## City of Ann Arbor

### HISTORIC DISTRICT COMMISSION

Re: 903 W Huron new submission

**ADDRESS:** 903 West Huron Street, Application Number HDC24-0089

Proposed Entry Ramp at:  
903 W. HURON ST.

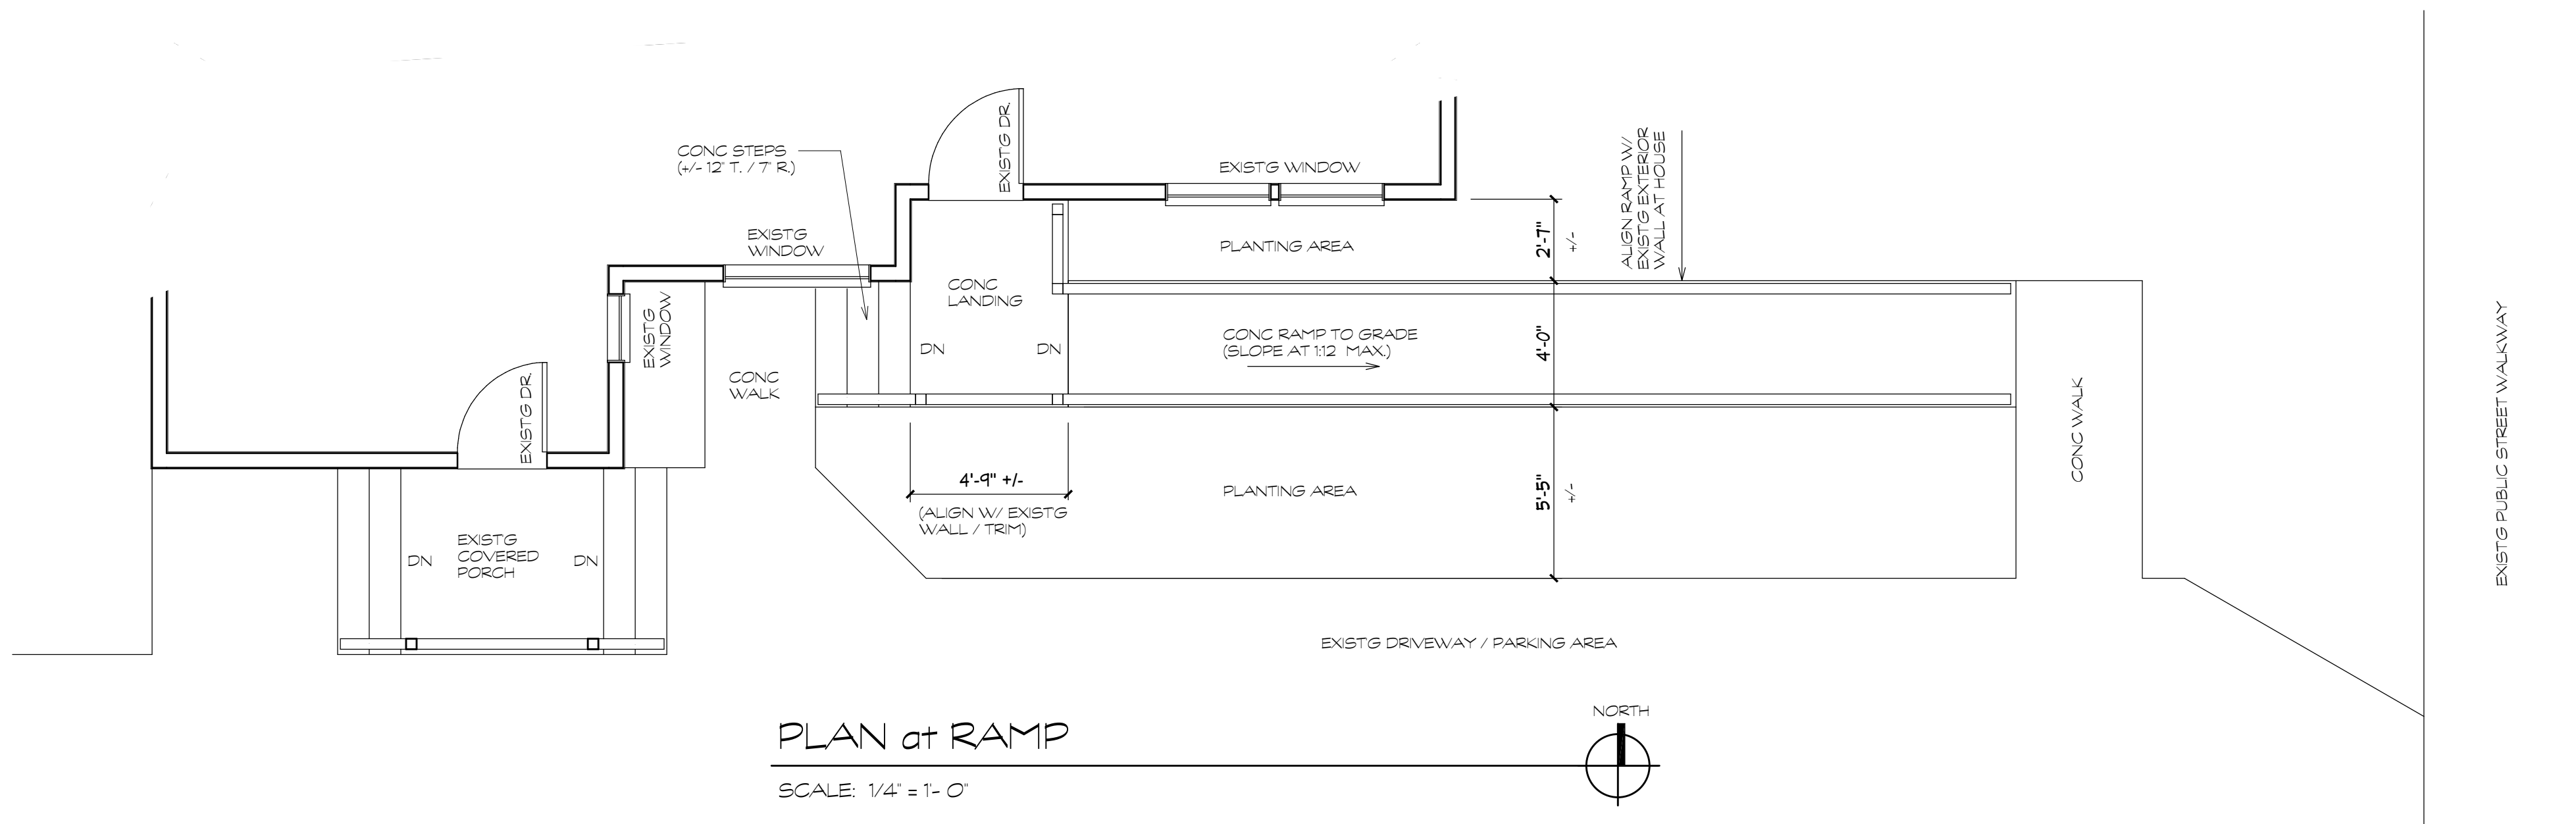
At the June 13, 2024 HDC meeting, part of the application at 903 W Huron was postponed to allow the applicant to adjust and complete the proposal to replace the rear window with a door and add a new stoop and ramp. The attached revised drawings show a paneled door in the location of the former window, but there is no further information regarding materiality or appearance of the door. The drawings show a new concrete landing, steps, and ramp that run parallel to the existing rear wall of the house. The ramp extends roughly 15 ft east beyond the southeast corner of the house. The ramp is approximately 4 ft wide and is surrounded to the north and south by new planting areas. The ramp will have a simple guardrail that appears to meet the design guidelines, but no material information was provided. A new concrete walk will connect the steps and ramp to the existing driveway. According to the drawings, the same guardrail design will also be installed at the existing covered porch west of the new door and ramp.

The HDC will need to determine if the replacement of the former window with the door and the new ramp are appropriate for rear access to the house. The June 13 staff report is attached after the new drawing set. Please note that the work on the front porch was issued a Certificate of Appropriateness at the June 13, 2024 HDC meeting.
